DESIGN REVIEW/PRESERVATION BOARD
SACRAMENTO, CALIFORNIA

ITEM NO. 7
JANUARY 31, 1996

PB95-057 - Addition of mechanical room and ornamental iron at patio to existing Essential Structure at 2324 L Street.

REQUEST: Preservation Review of a proposed addition of a mechanical room and patio fence to the existing Essential Structure in the Sutter's Fort Preservation Area.

EAST PATIO ENCLOSURE

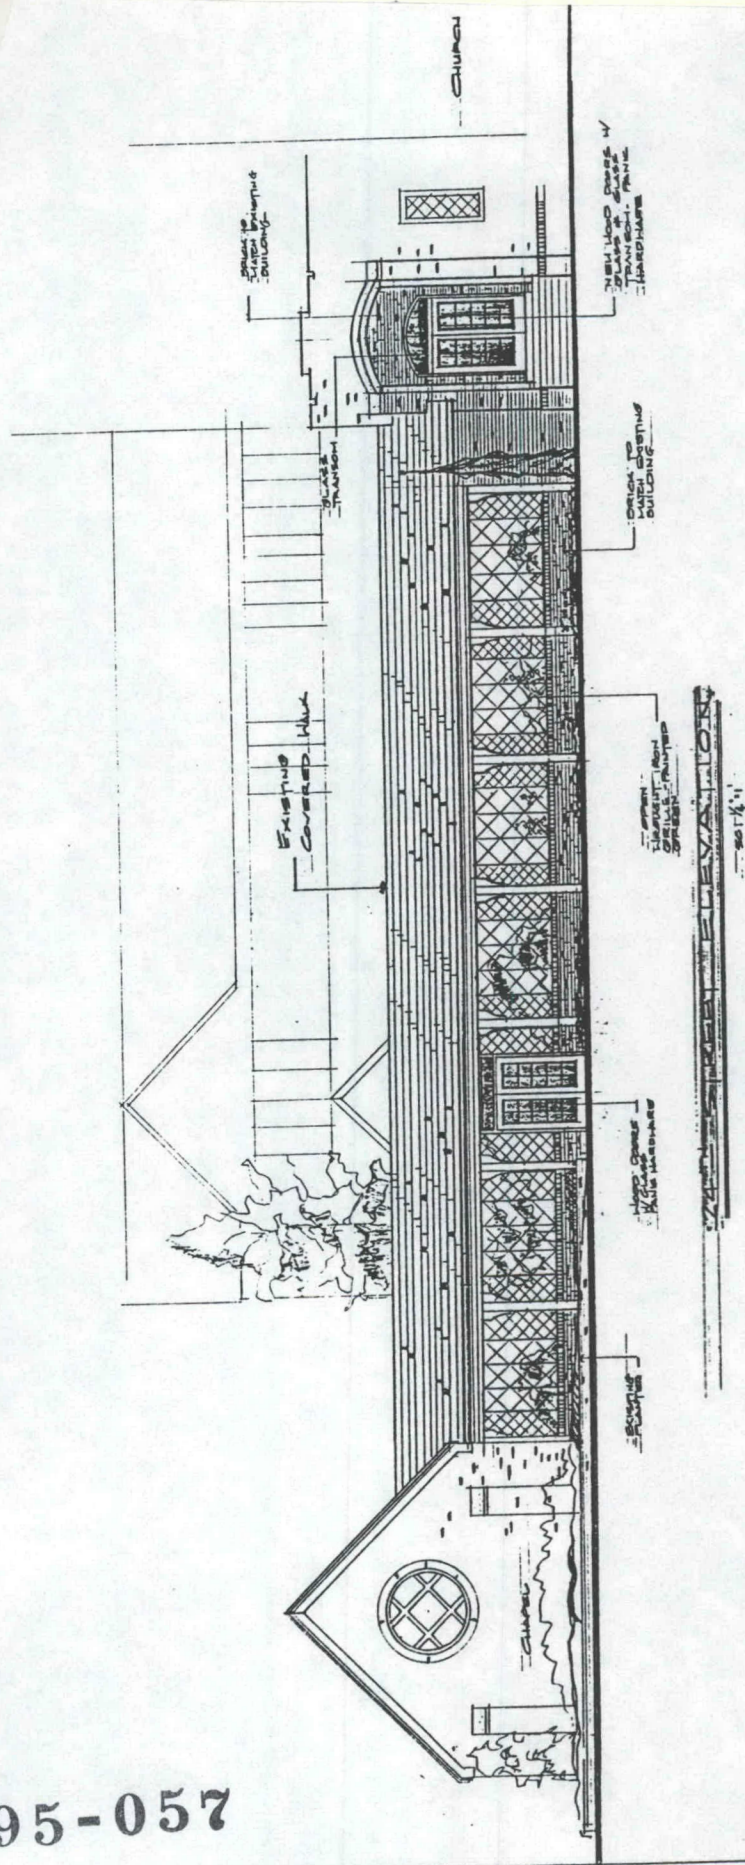
1. The applicant proposes to enclose the open arcade on the east elevation (24th Street) with a 30" high wainscot of brick that matches existing brick, and about 5'-0" of ornamental ironwork above in a pattern taken from the circular window on the east facade.
2. The ironwork consists of 3/8" diameter rods in a diagonal pattern with 2" X 3/8" flatbar acting as a frame for the rods. The ironwork will be placed between the existing decorative posts to remain and are detailed to meet the existing corbels which will also be retained. Staff has received the details for the proposed ironwork and feels they will enhance the existing wood arcade. A pale green color is proposed for the ornamental ironwork.
3. Two pairs of wood doors with divided lights are proposed to provide access to the interior courtyard adjacent to the arcade. The doors are in keeping with the building character and design.

4. The applicant proposes new brick jambs that matches existing brick, and ornamental iron grilles at the entry area on the east facade to provide security and privacy to the existing loggia area. The design proposed will serve to compliment the existing building's character and design.
5. A new brick planter adjacent to the entry to the loggia will be added to match the existing planter on the south end of the facade.

- A. The design of the proposed patio ironwork and grilles at entry (see attached plans) is hereby approved subject to the following conditions:
1. The proposed ornamental ironwork at the existing arcade shall be installed as proposed with a 30" high wainscot of brick that matches existing brick, and 5'-0" of ornamental ironwork above in a pattern taken from the circular window on the east facade.

2. The ironwork shall consist of 3/8" diameter rods in a diagonal pattern with 2" X 3/8" flatbar acting as a frame for the rods as indicated in the drawings. The ironwork shall be placed between the existing decorative posts to remain and detailed to meet the existing corbels which will also be retained. A pale green color as proposed shall be utilized for all ornamental ironwork.

3. Two pairs of wood doors with divided lights as proposed shall be provided to access the interior courtyard adjacent to the arcade. The doors shall be in keeping with the existing building character and design.

4. New brick jambs that match the existing brick, and ornamental iron grilles at the entry area on the east facade to provide security and privacy to the existing loggia area shall be installed as indicated on the drawings.

5. A new brick planter adjacent to the entry to the loggia shall be added to match the existing planter on the south end of the facade.
- B. The design of the proposed mechanical enclosure (see attached plans) is hereby approved subject to the following conditions:

PERSPECTIVE.
ARCADE FROM ALLEY.

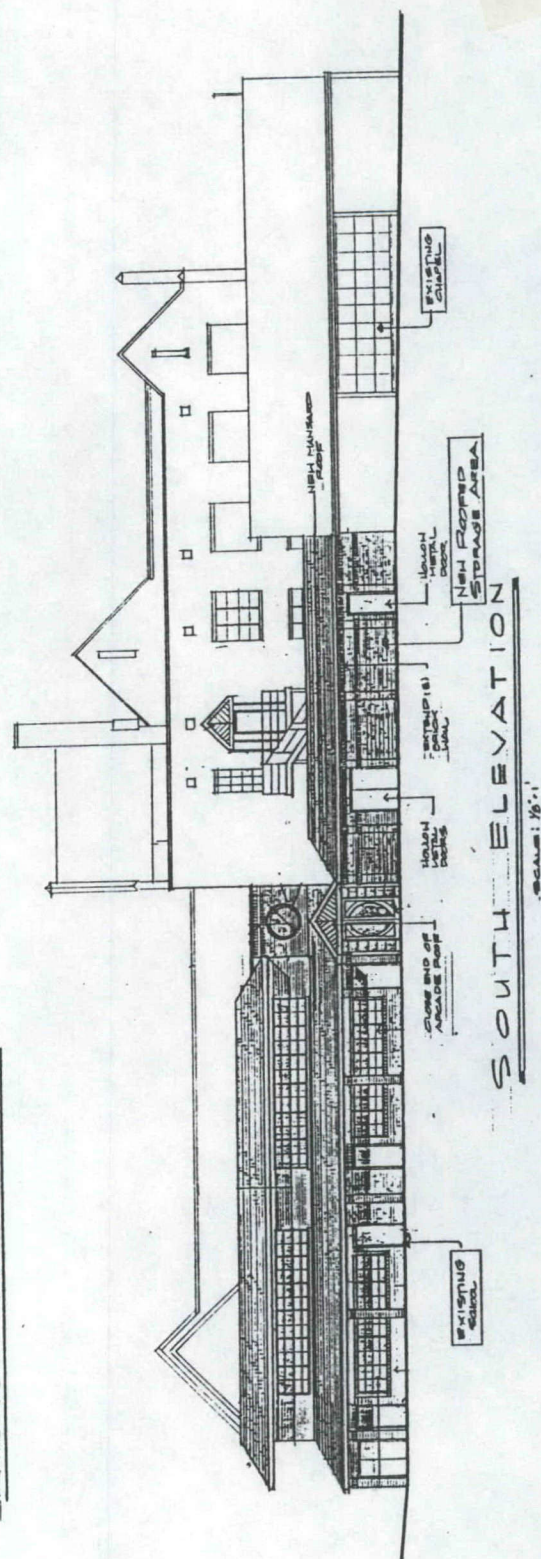
1. The applicant proposes to fully enclose an area on the south elevation (alley side) that is now partially enclosed with 6'-0' high brick walls.
2. The new enclosure consists of 8'- 0" high brick walls to match existing brick and a mansard roof with shingles to match existing. The brick enclosure with mansard roof will adequately screen equipment now fully visible from the parking area adjacent to the alley. In addition, the proposed enclosure will provide a more cohesive facade than currently exists.
3. The proposed enclosure will compliment the character and design of the existing building.

1. The new enclosure shall consist of 8'- 0" high brick walls to match existing brick and a mansard roof with shingles to match existing. The brick enclosure with mansard roof shall serve to adequately screen equipment now fully visible from the parking area adjacent to the alley.

2. The proposed enclosure shall compliment the character and design of the existing building.
 3. The final colors shall be submitted for review and approval of staff.
